20/5/19

FLOREA A & D

SECOND FLOOR PLAN.

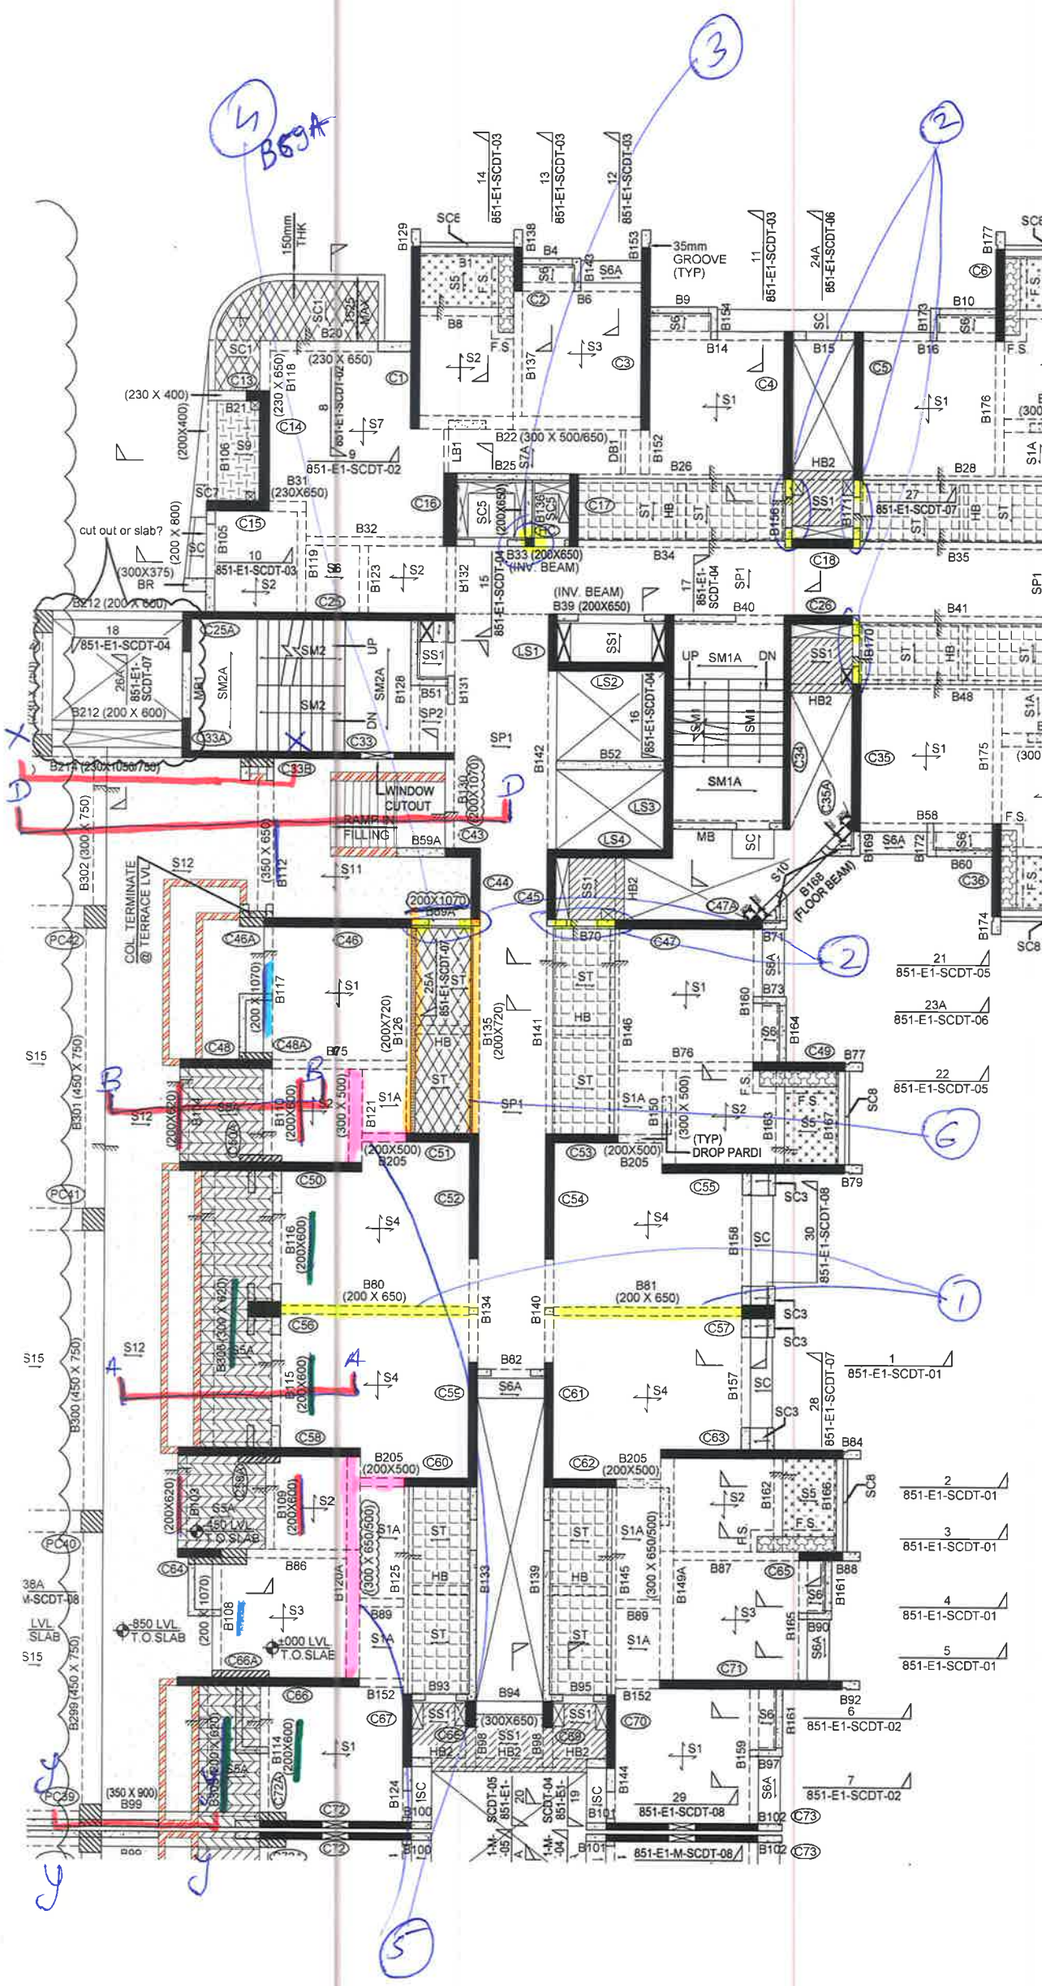
(1) 230 wide beam as per Shell dwg approval.

(2) Non. Struc. wall extent to be as per Arch. dwg.

(3) Column HC was not a part of Shell dwg. Will it be only on this floor??

(4) Refer section attached for comments.

(5) B120A can be 300X650 only.

(6) Slab thk of 'ST' to be known for B126 & 135 depth to be finalized.

B109/110
B103/104
SECTION BB.

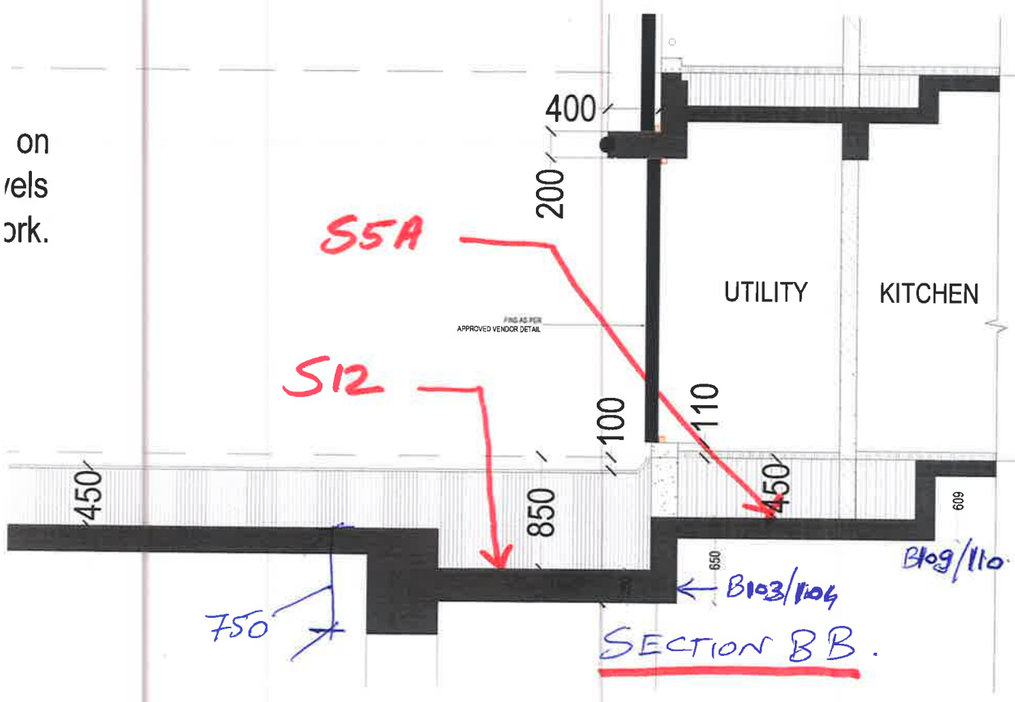
① If S12 is 250 thk then B103 & 104 can be 650 deep.
② If S5A is 200 thk then B109 & 110 can be 650 deep.

SECTION DD/CC

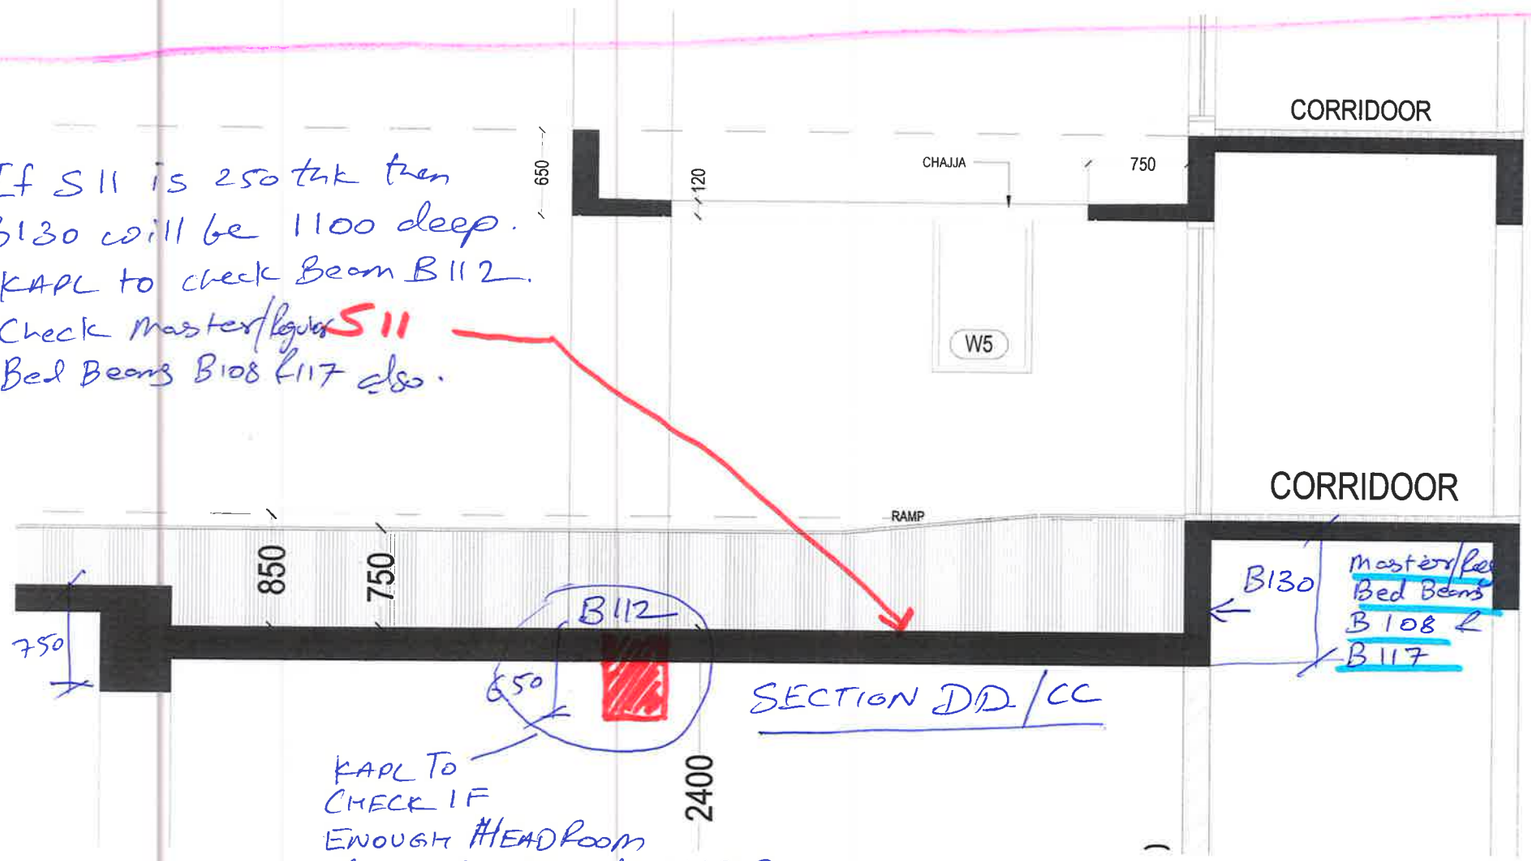
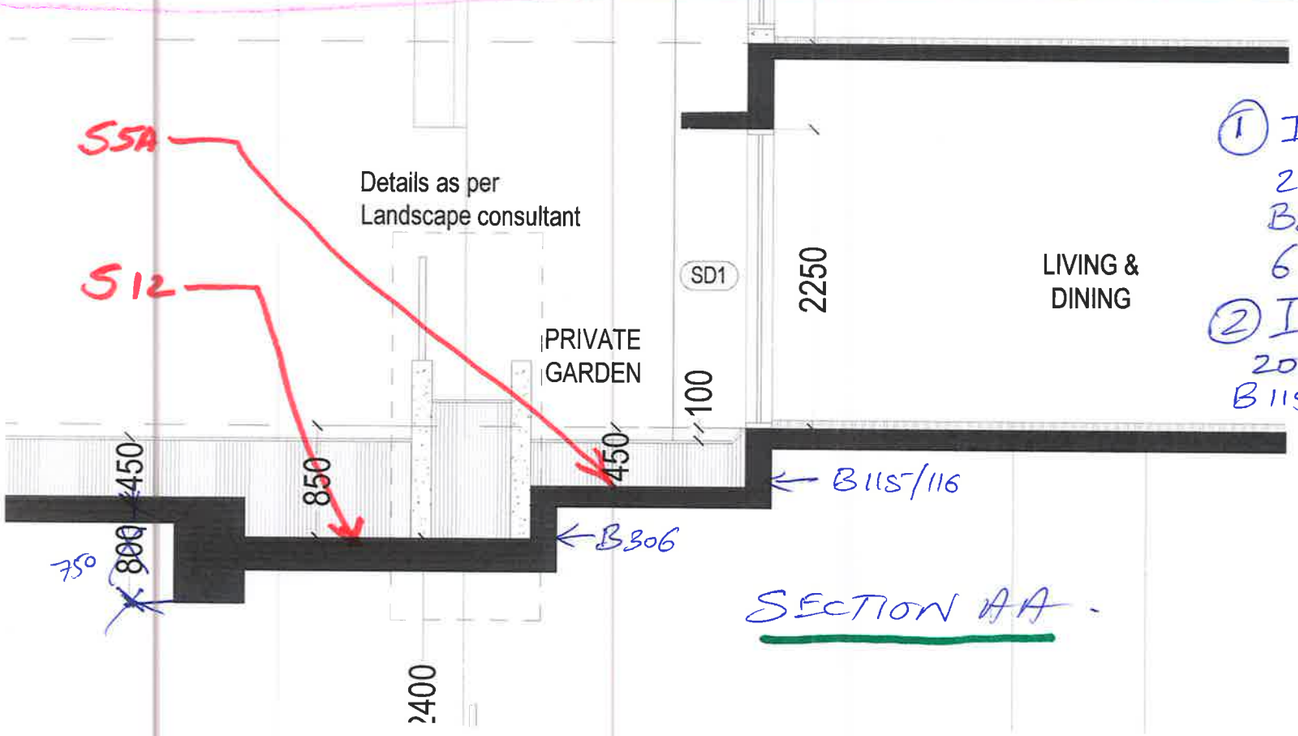
① If S11 is 250 thk then B130 will be 1100 deep.
② KAPL to check Beam B112.
③ Check Master/Regular Bed Beams B108 & 117 also.

KAPL TO CHECK IF ENOUGH HEADROOM ABOVE LOFT IS AVAILABLE

SECTION AA.

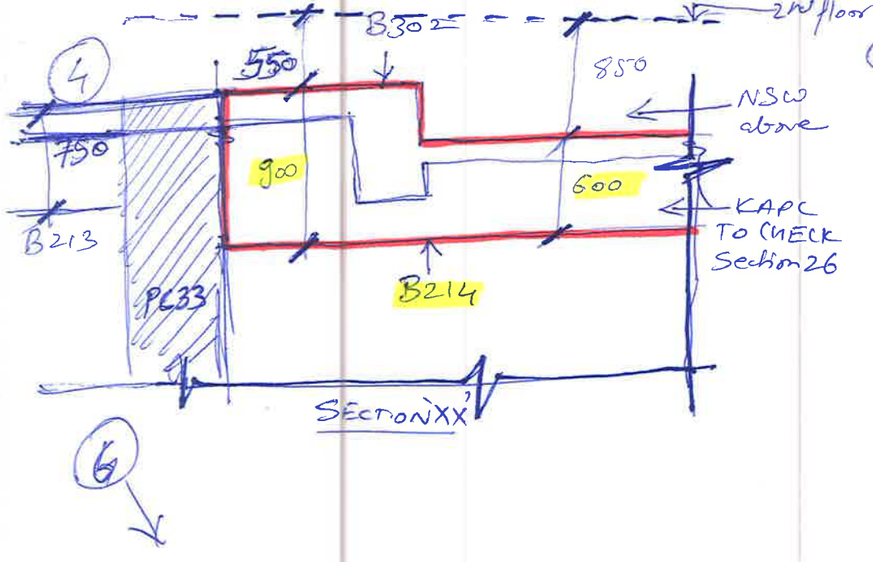
① If S12 is 250 then B306 can be 650 deep.
② If S5A is 200 thk then B115 & 116 can be 650 deep.

SECTION 25

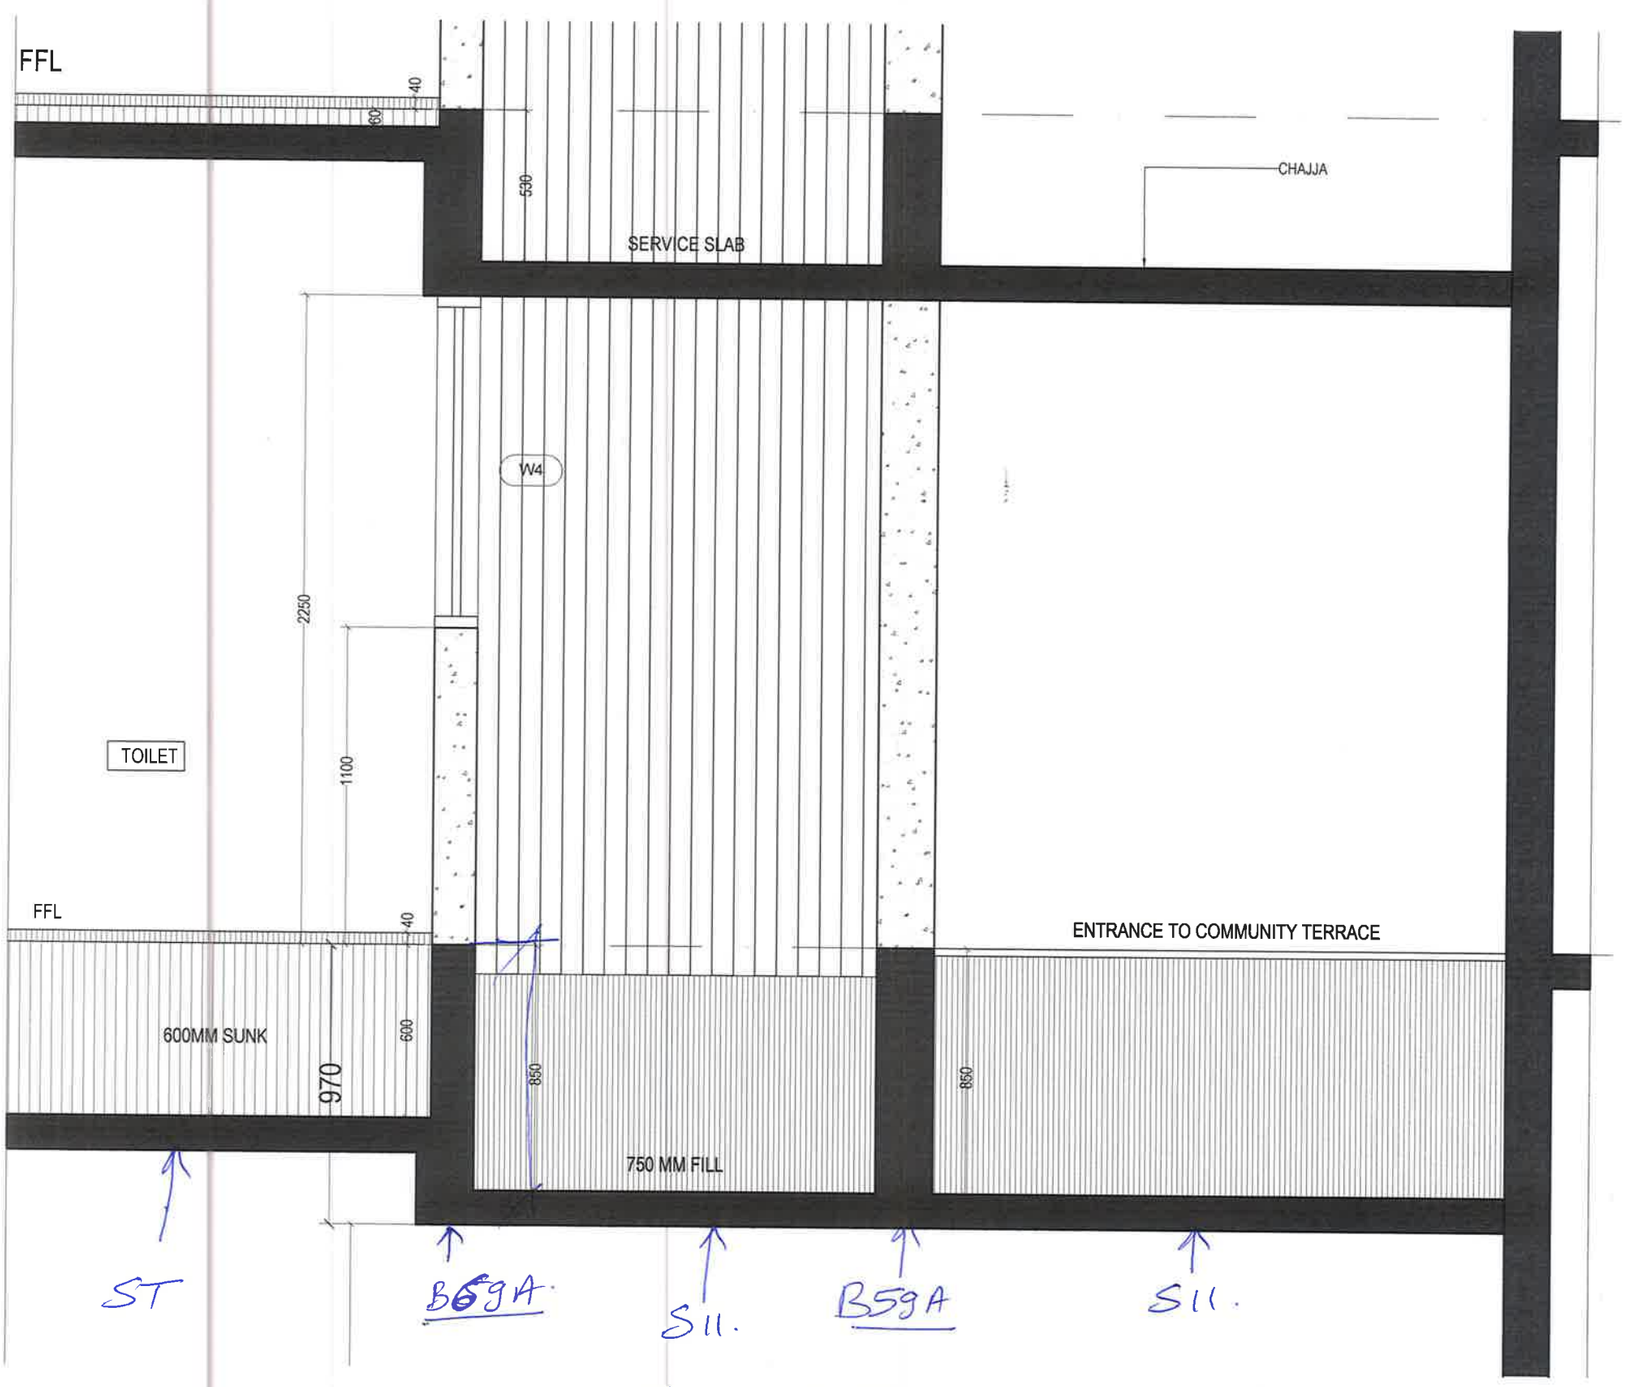
(1) If S11 is 250 then B69A & 59A will be 1100 mm.

(2) Slab 'ST' thk required.
